**AUTOMATED GROUNDWATER SCREENING**

**REPORT DATE: OCTOBER 31, 2005**

**Appendix B. Reviewer Comments..... 31**

Figure 3-1 Flowchart of Groundwater Screening Coding

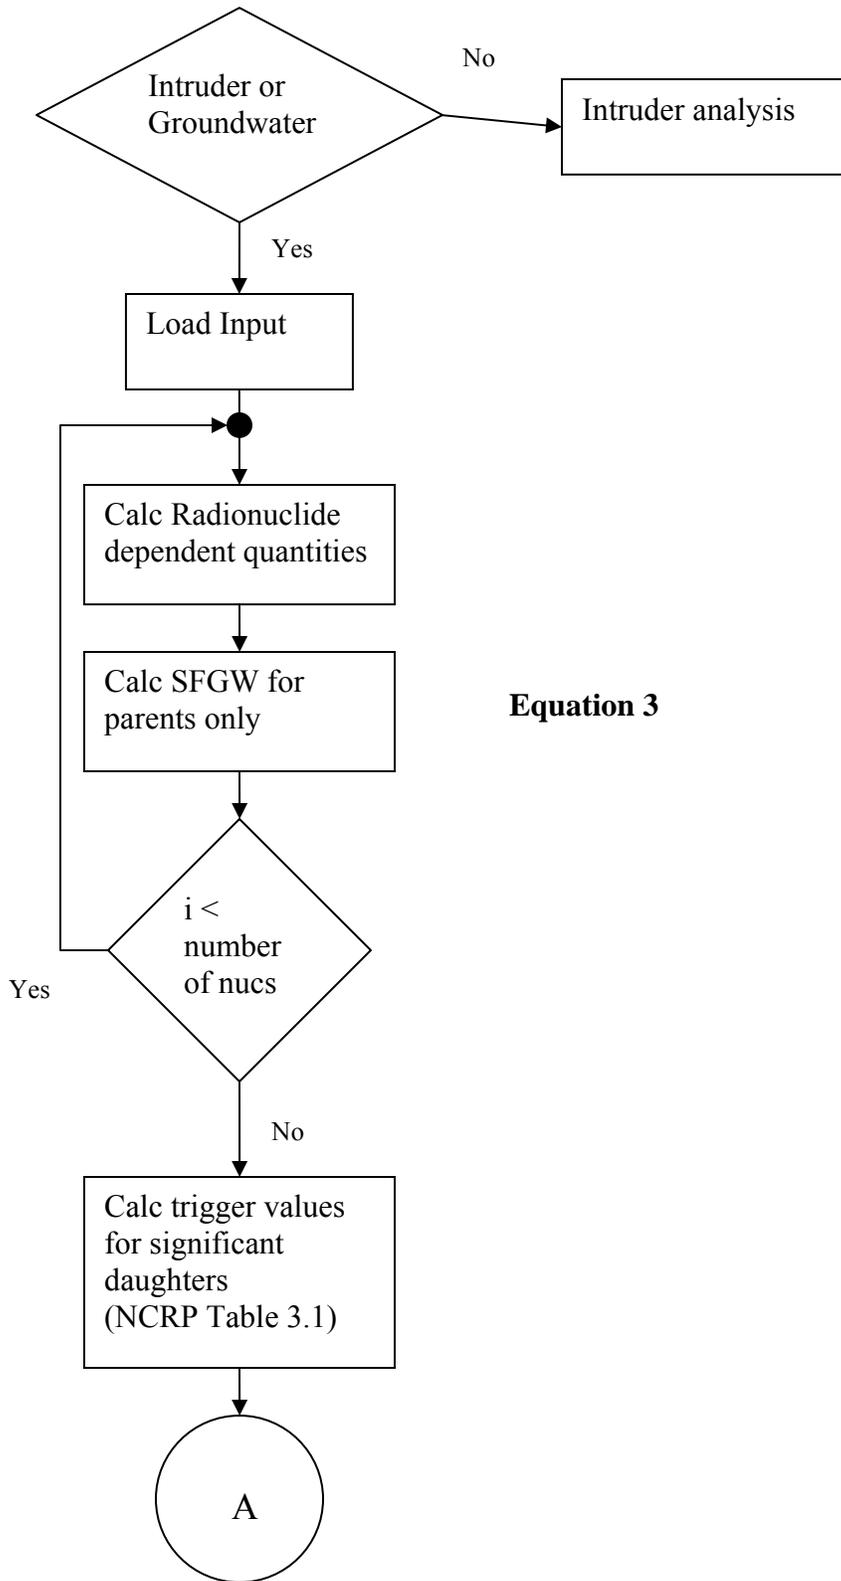
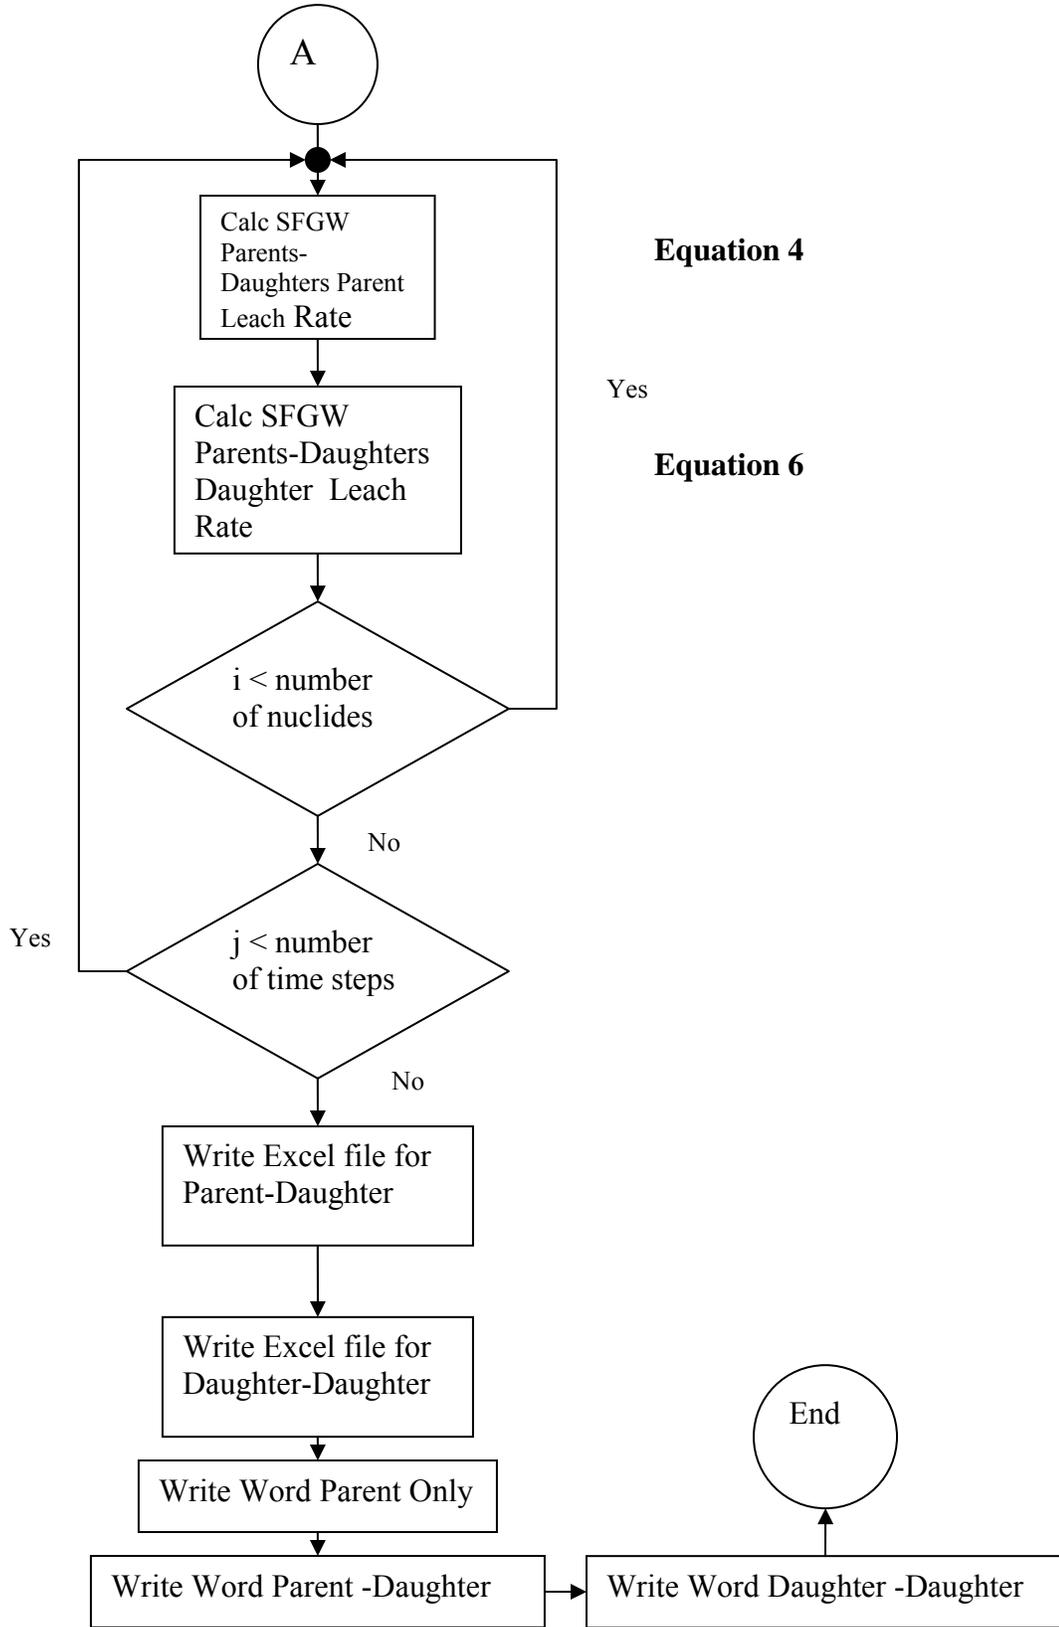
*Item 7. Verify that the equations of the report are correctly implemented in the coding.*

I went through the coding and verified that the coding correctly implements the equations in the report. However, there is one caveat. The logic for indices into arrays is only correct if all parents are selected. That is, the calculations would not be correct for a subset (it turns out that choosing a subset fails because of an array dimension mismatch). I recommend removing the option to use a subset in the application and changing the text in the report accordingly (e.g. on p. 14). *Response: Done.*
